Agenda Item # 12

SUB-002962-2024

Bryant Addition Subdivision

APPLICATION NUMBER 12 DATE June 20, 2024

DETAIL SITE PLAN

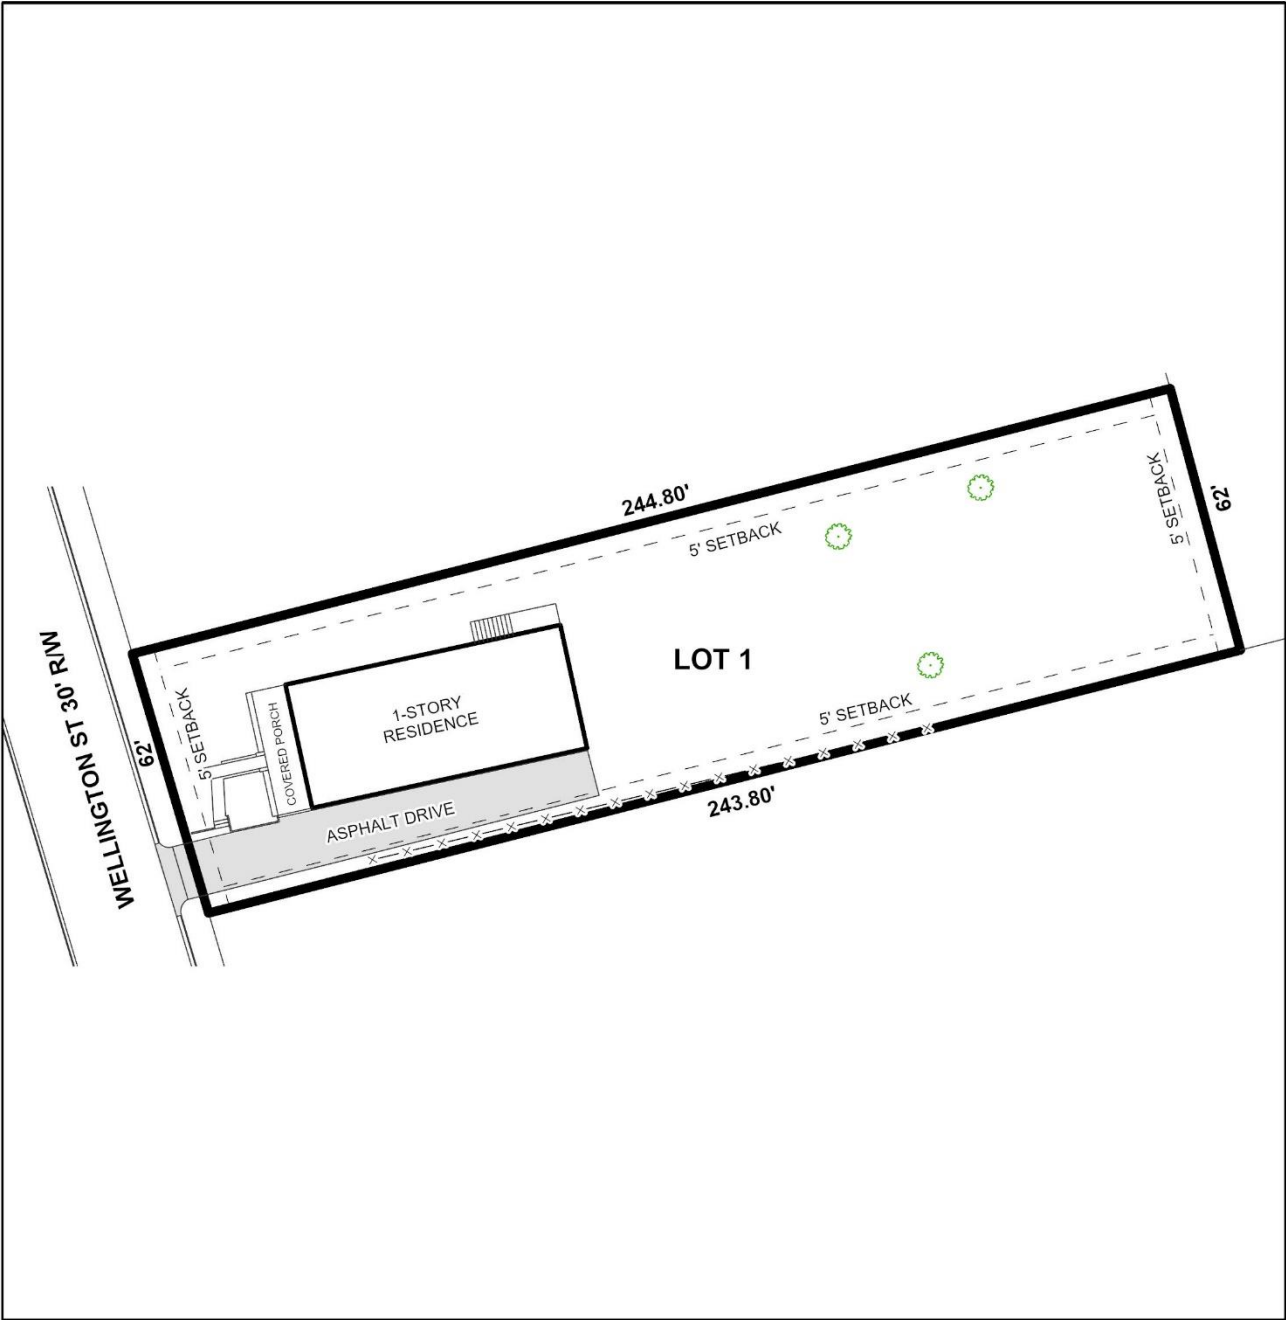
The proposed lot has frontage on Wellington Street, a minor street with curb and gutter requiring a 50-foot right-of-way. The plat submitted illustrates a substandard 30-foot right-of-way; however, GIS data indicates Wellington Street has an existing right-of-way that may be compliant. If approved, dedication would be required to provide 25 feet from the centerline of Wellington Street, if needed.

If approved, the plat should be revised to illustrate the 5-foot minimum building setback line along Wellington Street as measured from any required dedication. The five-foot setback lines along the side and rear property lines should be removed on the Final Plat, if approved. The lot size is not labeled on the preliminary plat. If approved, the plat should be revised to label the lot with its size in both square feet and acres, after any required dedication, or a table should be furnished on the Final Plat providing the same information.

As proposed, the lot would exceed the depth-to width ratio of Section 6.C.3. of the Subdivision Regulations and would require a waiver of that section, if approved.

1. Provision of a subdivision plat in compliance with Section 5 of the Subdivision Regulations;
2. Dedication to provide 25 feet from the centerline of Wellington Street, if needed;

3. Revision of the plat to illustrate the 5-foot minimum building setback line along Wellington Street as measured from any required dedication;
4. Revision of the plat to remove the 5-foot building setback line along the side and rear property lines;

5. Revision of the plat to label the lot with its size in both square feet and acres, after any required dedication, or the furnishing of a table on the Final Plat providing the same information;
